**GEARY ELEMENTARY / MIDDLE SCHOOL
PAVEMENT REPAIR AND IMPROVEMENTS**

ADDENDUM #2

JUNE 2, 2021

THRASHER PROJECT #060-0989

SHEET No.
C1.01R1

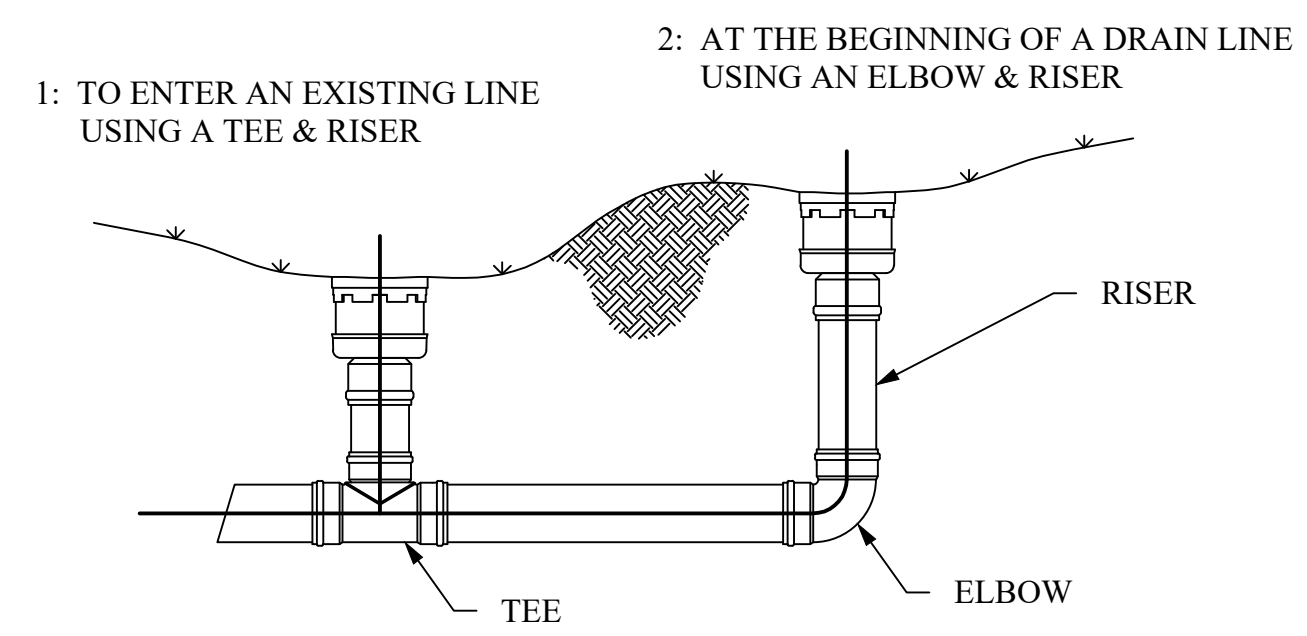
NO.	BY	DATE	DESCRIPTION
1	CLM	06/01/21	ADDED NOTE REGARDING PROPOSED CONCRETE SLAB AND APRON.

CONCRETE APRON SECTION
 NOT TO SCALE

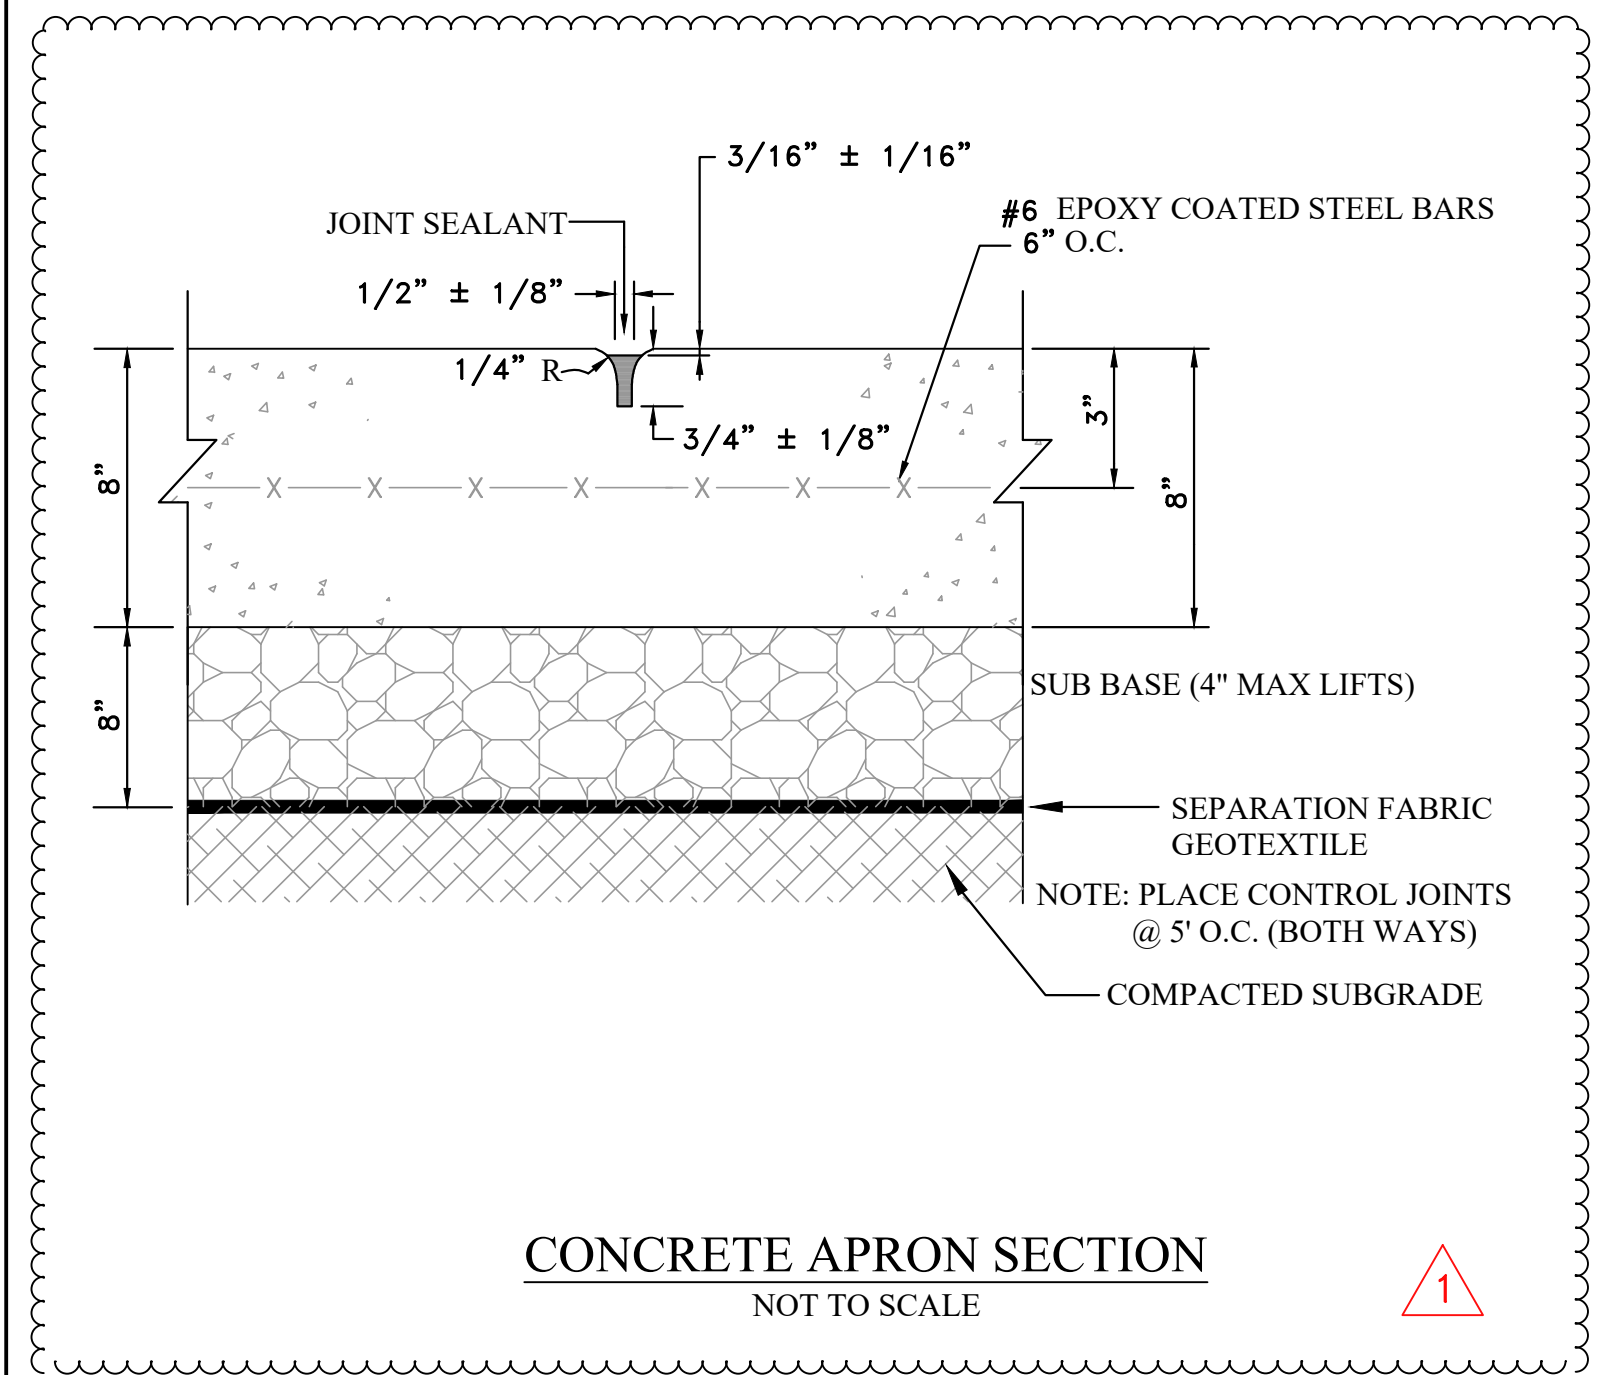
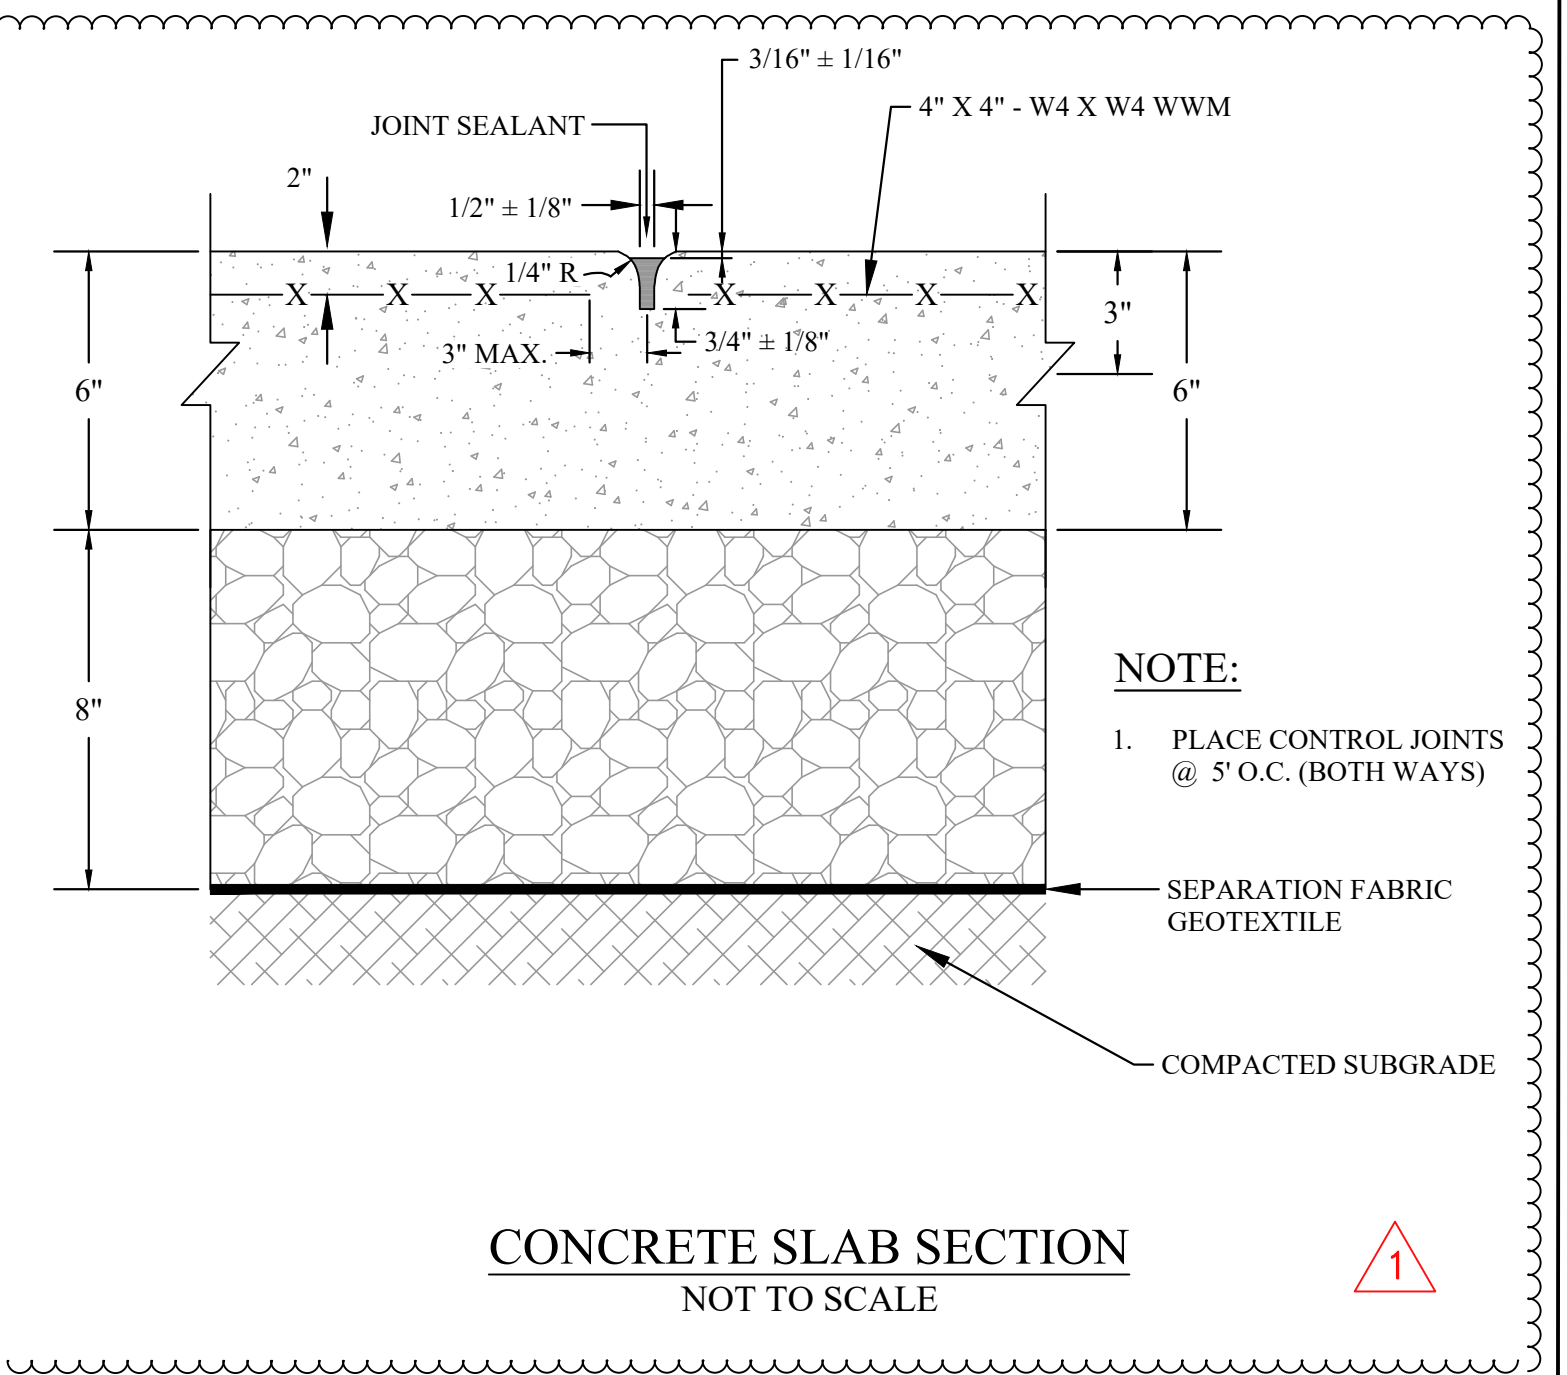
2. **Comment:** Will the Trash Enclosure need to include a new concrete pad or be placed on the existing asphalt.

NO.	BY	DATE	DESCRIPTION
1	CLM	06/01/21	ADDED CONCRETE APRON AND SLAB SECTION DETAILS.

Response: The proposed Trash Enclosure Detail has been revised to include a proposed concrete slab and apron. Detail for the proposed concrete slab and apron sections have been added to Sheet C2.02 of the plan set.
